AIRWORTHINESS DIRECTIVE

No. 2025-FATA-010144R-05

Applicability – ANSAT helicopters (ANSAT, ANSAT-GC models) and their modifications

TECHNICAL DECISION No. 1/144-2023-KB3
on continued airworthiness of the ANSAT helicopters (ANSAT, ANSAT-GC models)
Issue 2

Figure 201 – Inspection card of the blade No. of the tail rotor No.
(to be completed in case of detection of defects)

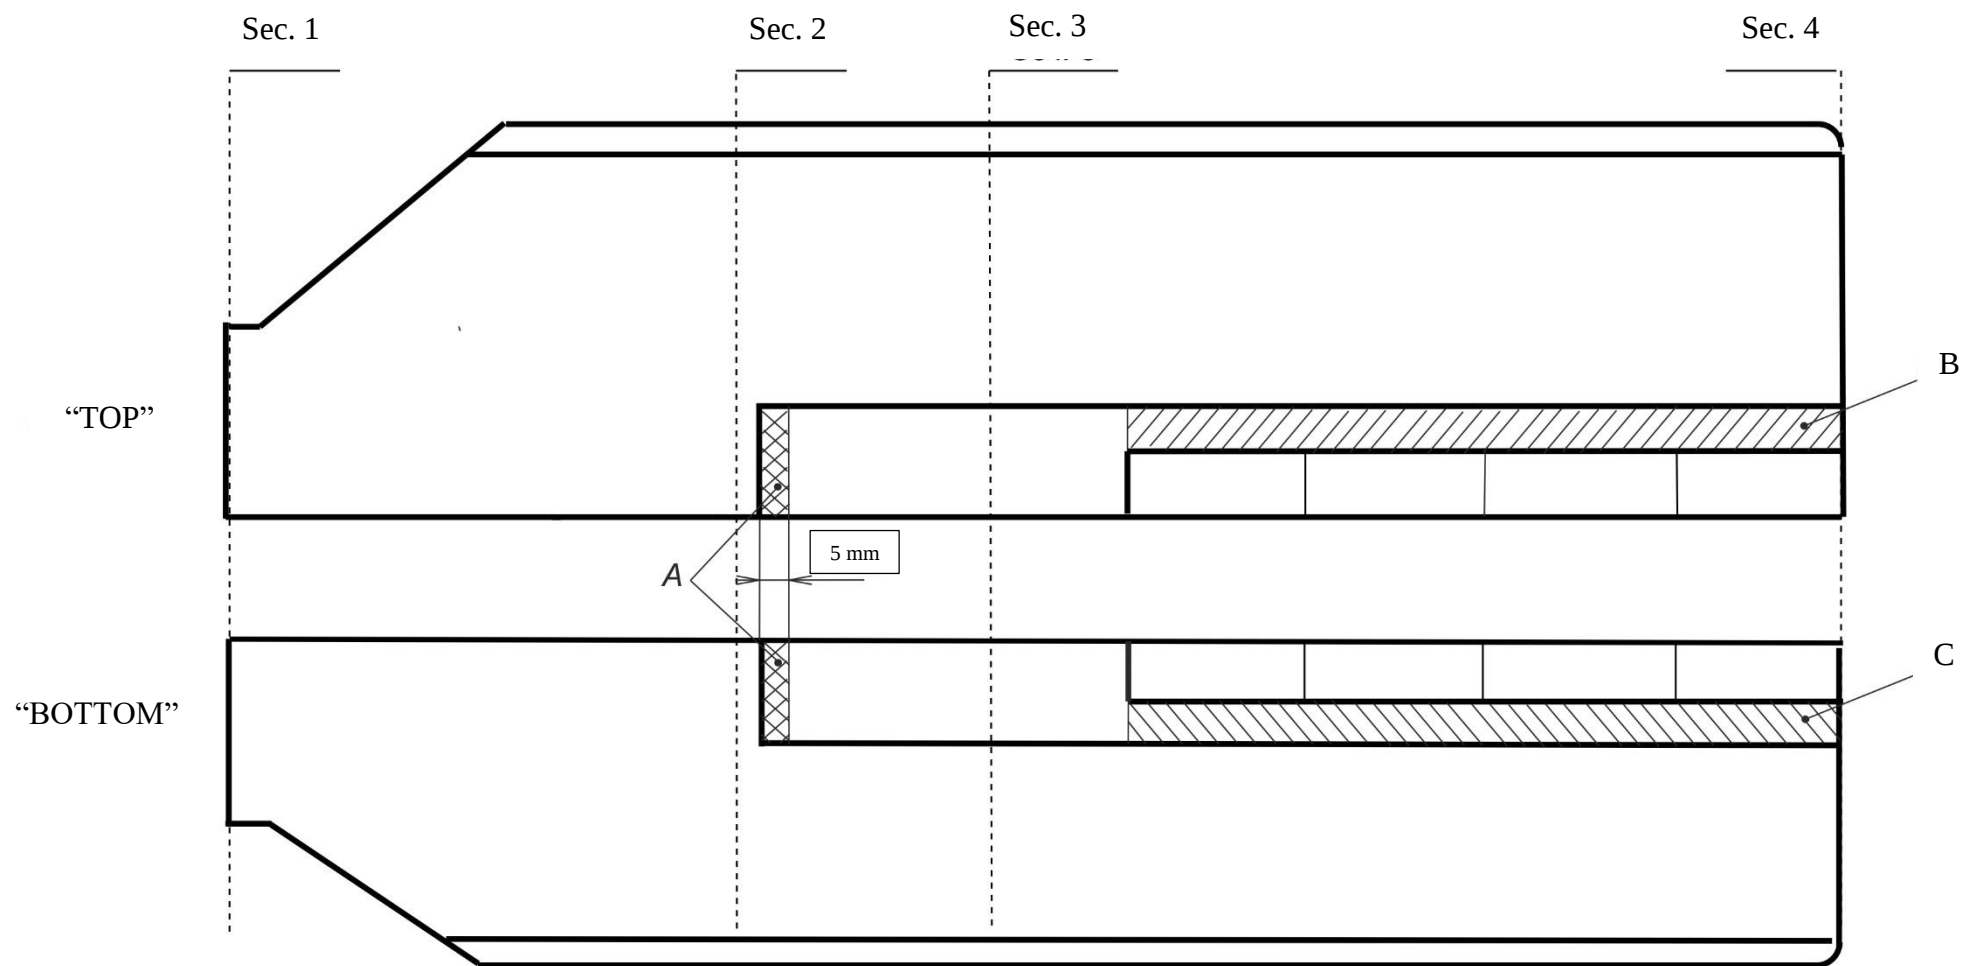
The presence of non-glueing of the strips (4) and blade edge tippings (5) is not allowed. If any defects are detected, complete the inspection card* of tail rotor blade (see figure 201), make marks on the tail rotor blades with a soft pencil, and take pictures of the defects. 5 Check the absence of the rubber layer non-glueing of the strips (2) and blade edge tippings (3) by tapping with a duralumin hammer, for this purpose tap the entire area of the strips (2) and blade edge tippings (3) with a free fall of the duralumin hammer from a height of no more than 10 ... 15 mm or with soft blows from a distance of no more than 10 mm, avoiding traces of tapping. Violation of glueing is characterized by a change in tone. The presence of the strips (2) rubber layer non-glueing is not allowed (except for areas A, B, C (see figure 201)). Elimination of non-glueing in the areas A, B, C (see figure 201) shall be carried out in the course of operation according to the procedure described in section 020.10.00. The presence of the blade edge tippings (3) non-glueing is not allowed. If any defects are detected, complete the inspection card* of tail rotor blade (see figure 201), make marks on the tail rotor blades with a soft pencil, and take pictures of the defects. 6 Based on the results of works, draw up the inspection report according to the Appendix 3. The report for each periodic inspection (with an inspection card and photographic materials) should be attached to the tail rotor certificate. * Note: – Information about defects is completed in one inspection card of tail rotor blade.			Send the tail rotor to the JSC “Kazan Helicopters” for investigation and repair. Send the tail rotor to the JSC “Kazan Helicopters” for investigation and repair. Send the tail rotor to the JSC “Kazan Helicopters” for investigation and repair.

Figure 202 – Tail rotor blade

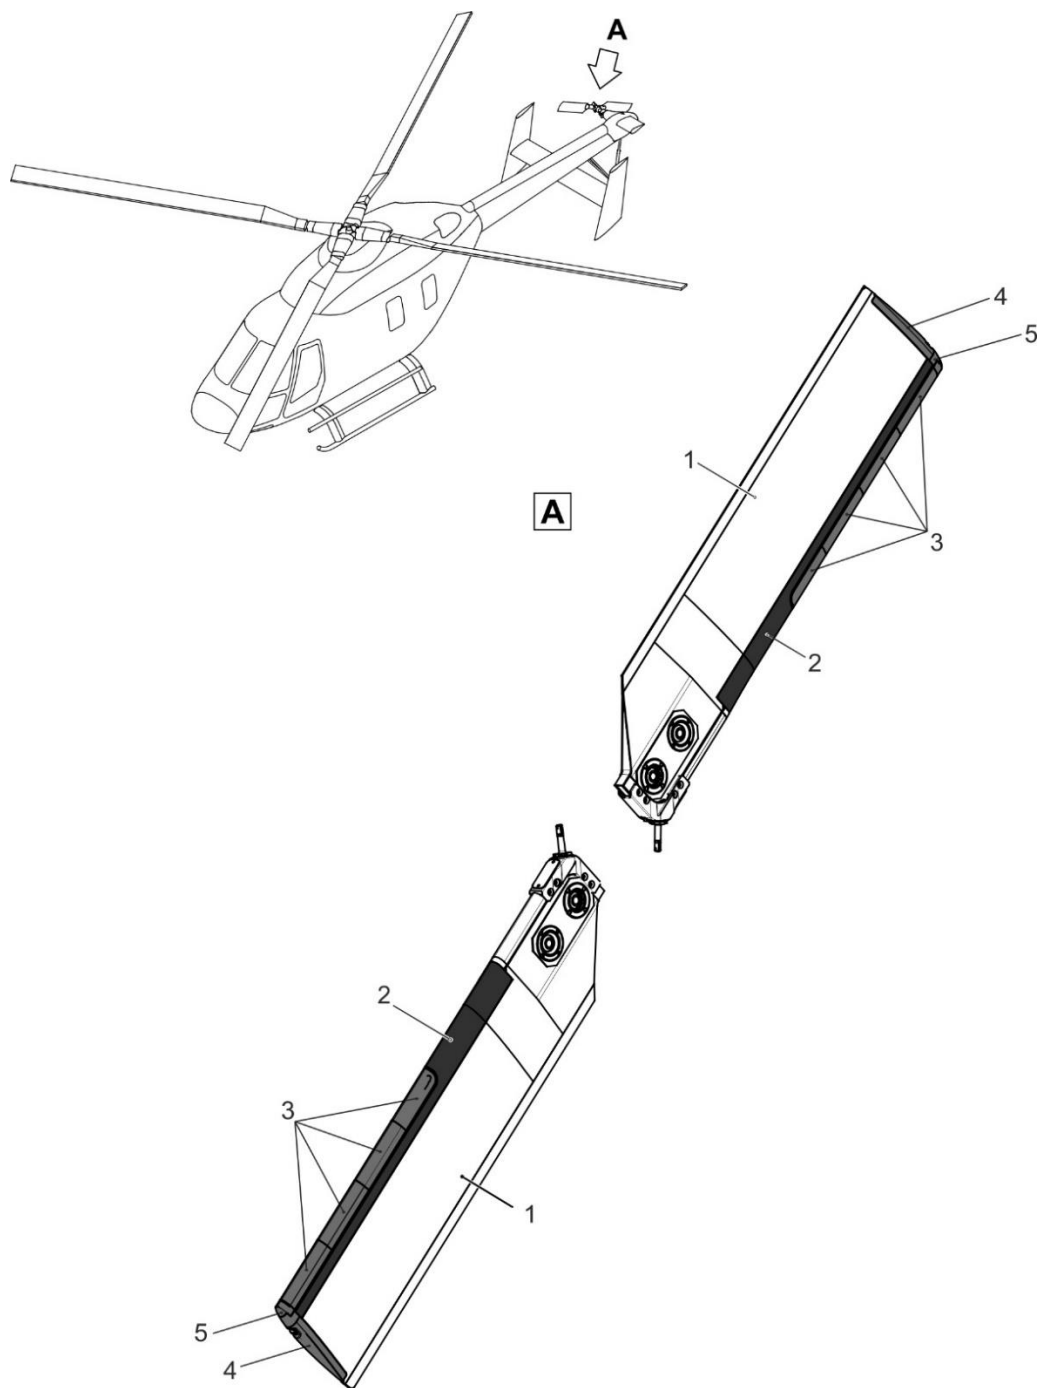
- defects of the blades in the form of non-glueing of the rubber layer of strips (2), blade edge tippings (3), as well as tips (4) and blade edge tippings (5) (see fig. 202, Appendix 2), exceeding the permissible ones according to the temporary task card 064.10.001,

shall be removed from the operation and sent to JSC "Kazan Helicopters" for the purpose of investigation and repair.
